# Access Compliance Report

## Public Rights-of-Way

### (Curb Ramps)

Intersection ID: 50544	Main Street: ALCEA_ST	Cross Street: CAYENNE_DR	Location: E
ADA ID: 5DD071DA9A4A	Ramp Type: Perpendicular Diagonal	Initial Pass/Fail: Fail	Overall Compliance: No
Severity Score: 13.75			
Codes/Mitigation Info/Possible Solution		Field Measurements/Component Compliance

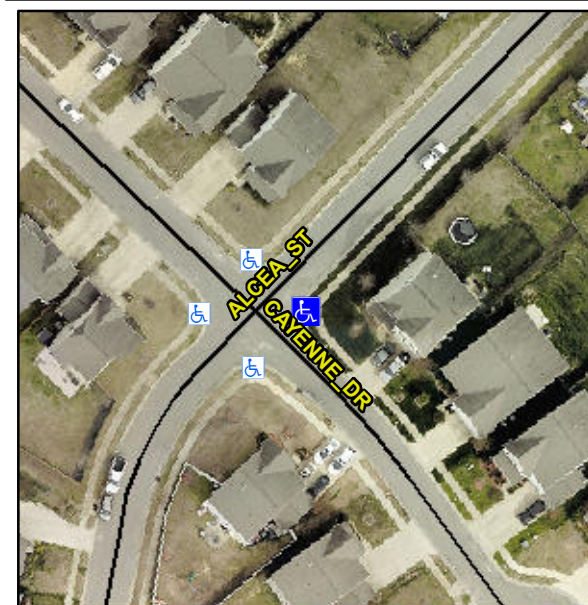
**Not Found, R304.2.2, R304.5.3**

Compliance	Description	Data	Compliance	Description	Data
N/A	Ramp Length (in)	48.0	No	Ramp Slope (%)	8.8
Yes	Ramp Width (in)	48.0	No	Ramp XSlope (%)	2.4
N/A	Flare Type LT	N/A	N/A	Flare Type RT	N/A
N/A	Flare Slope LT (%)	N/A	N/A	Flare Slope RT (%)	N/A
N/A	Flare Traversable LT?	N/A	N/A	Flare Traversable RT?	N/A
N/A	Landing Length (in)	N/A	N/A	DWS Provided?	N/A
N/A	Landing Width (in)	N/A	N/A	DWS Contrast?	N/A
N/A	Landing Slope (%)	N/A	N/A	DWS Length (in)	N/A
N/A	Landing X Slope (%)	N/A	N/A	DWS Full Width?	N/A
N/A	Landing Curb? (Y/N)	N/A	N/A	DWS Offset (in)	N/A
N/A	Shared Landing?	N/A			
N/A	Gutter Ponding?	Yes	N/A	Gutter Slope (%)	N/A
N/A	Gutter Lip Ht (in)	N/A	N/A	Gutter X Slope (%)	N/A
N/A	Painted X Walk1?	No	N/A	Painted X Walk2?	No
	X Walk 1 Direction	To NW		X Walk 2 Direction	To SW
N/A	X Walk 1 Width (in)	N/A	N/A	X Walk 2 Width (in)	N/A
	X Walk 1 Slope (%)	0.2		X Walk 2 Slope (%)	0.2
	X Walk 1 X Slope (%)	0.9		X Walk 2 X Slope (%)	1.5

**Remove & Replace Curb Ramp With Two New Directional Ramps or Equivalent.**
